<b>Docket Number:</b>	15-BSTD-05
<b>Project Title:</b>	2016 Nonresidential Compliance Manual and Documents
<b>TN #:</b>	205939
<b>Document Title:</b>	Robert A. Shearer Comments: NRCA-LTI-03-A 07 Default LED Illumination to Power Line on Dfc Graph
<b>Description:</b>	N/A
<b>Filer:</b>	System
<b>Organization:</b>	Robert A. Shearer, BSEE
<b>Submitter Role:</b>	Other Interested Person
<b>Submission Date:</b>	8/31/2015 12:43:25 PM
<b>Docketed Date:</b>	8/31/2015

**NRCA-LTI-03-A 07 Default LED Illumination to Power Line on Dfc Graph**

**Re: Docket # 15-BSTD-05**  
**2016 Acceptance Testing Forms: Comment 07**

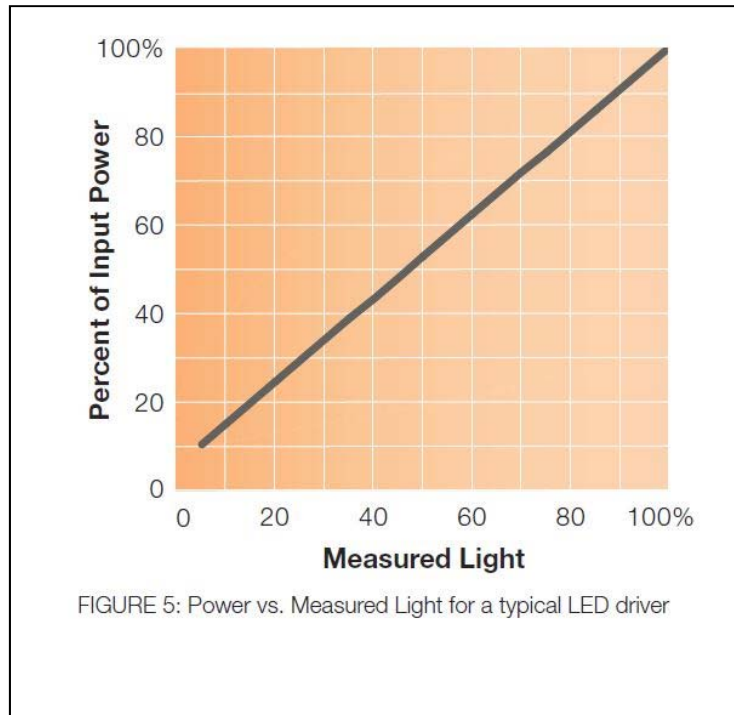
Regarding previous discussions with CEC staff – no “Default Line” is presented on page 8 of the Automatic Daylighting Control Acceptance Testing for: Continuous Dimming Systems ... Power estimation using light meter measurement.

It is suggested that the default power-to-illumination chart provided by a “Technical white paper”<sup>\*</sup> prepared by LUTRON, (Page 6, Figure 5. At - [http://www.lutron.com/TechnicalDocumentLibrary/367-2035\\_LED\\_white\\_paper.pdf](http://www.lutron.com/TechnicalDocumentLibrary/367-2035_LED_white_paper.pdf) ), be adopted, (or used as a model).<sup>\*\*</sup>

Without any further comment the Illumination-to-Power Graph is shown here:

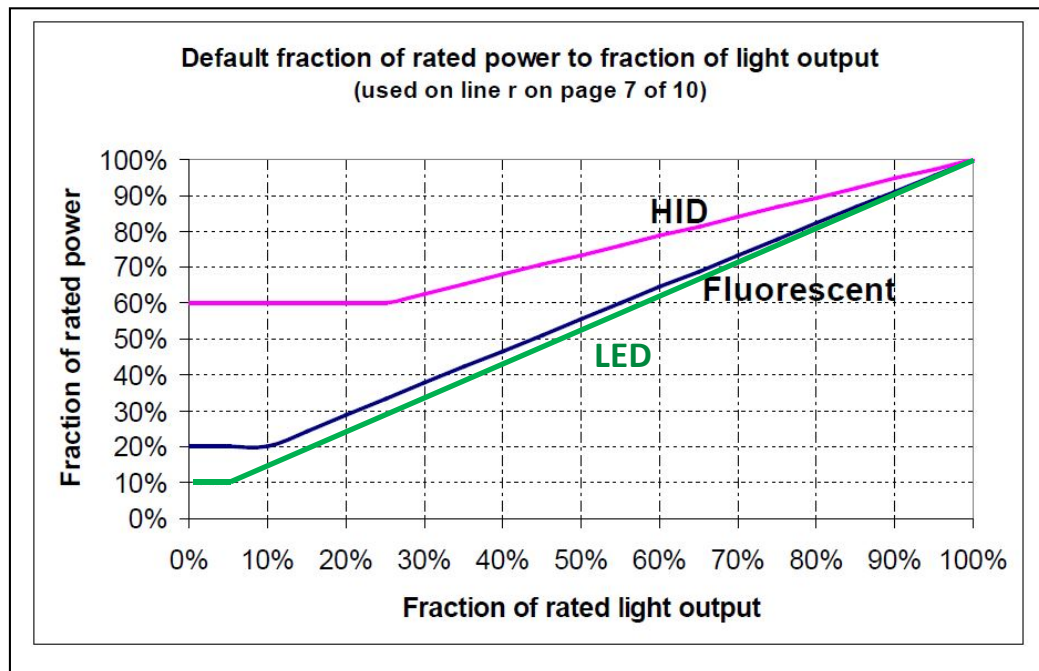
... And this would appear on NRCA-LTI-03-A, page 8, in a manner similar to this:
